GIECK RANCH MAIN STEM TRIBUTARY 1 & 2 FINAL DRAINAGE REPORT for DESIGN AND CONSTRUCTION

June 21, 2024

PCD File No. CDR228

HEC-RAS Plan: Proposed River: ChannelB Reach: Combined PR Chan Profile: PF# 1 (Continued)

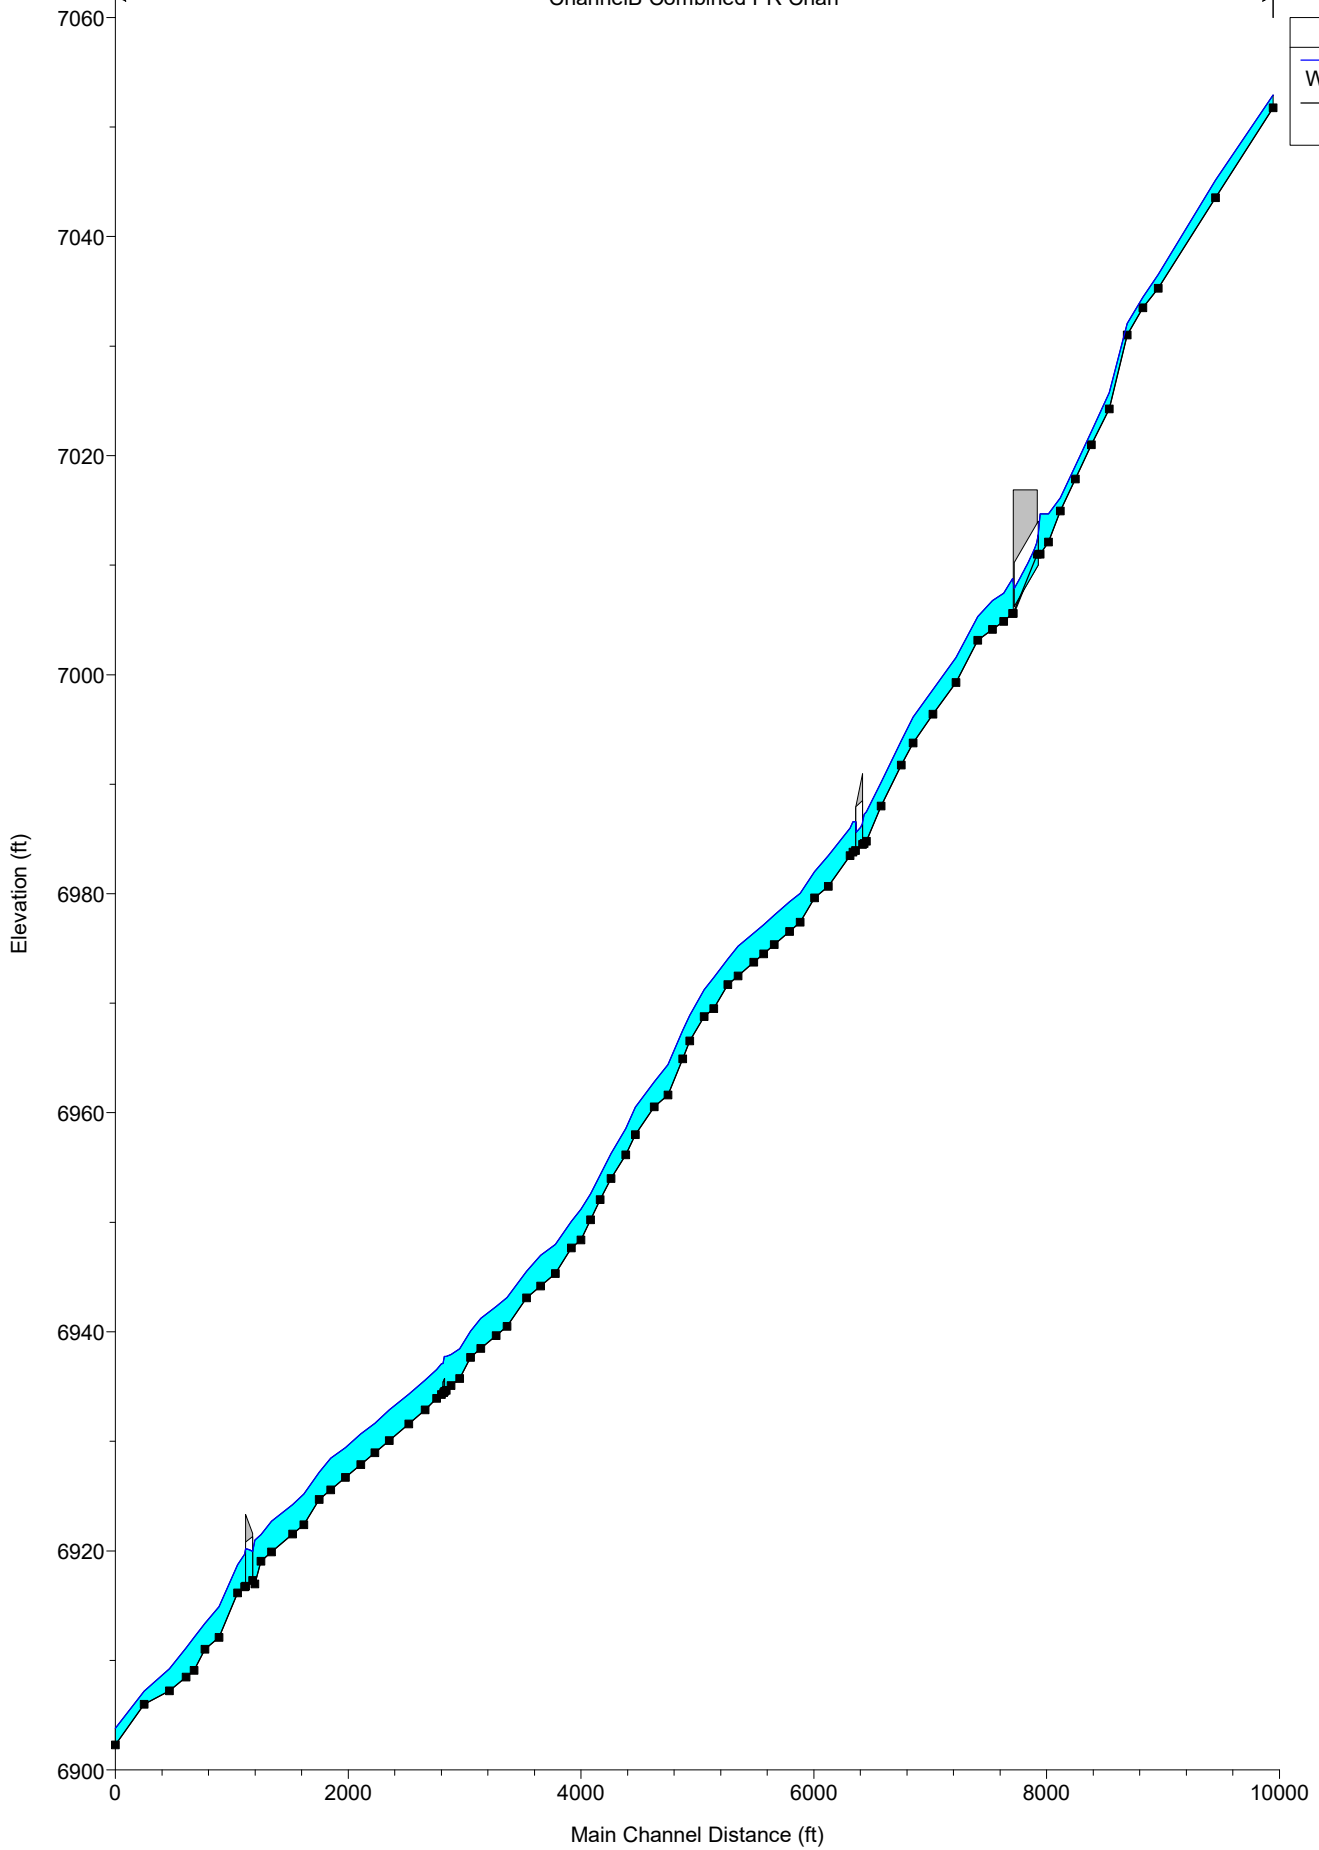
Also provide tables for 2-year and 10-year flows
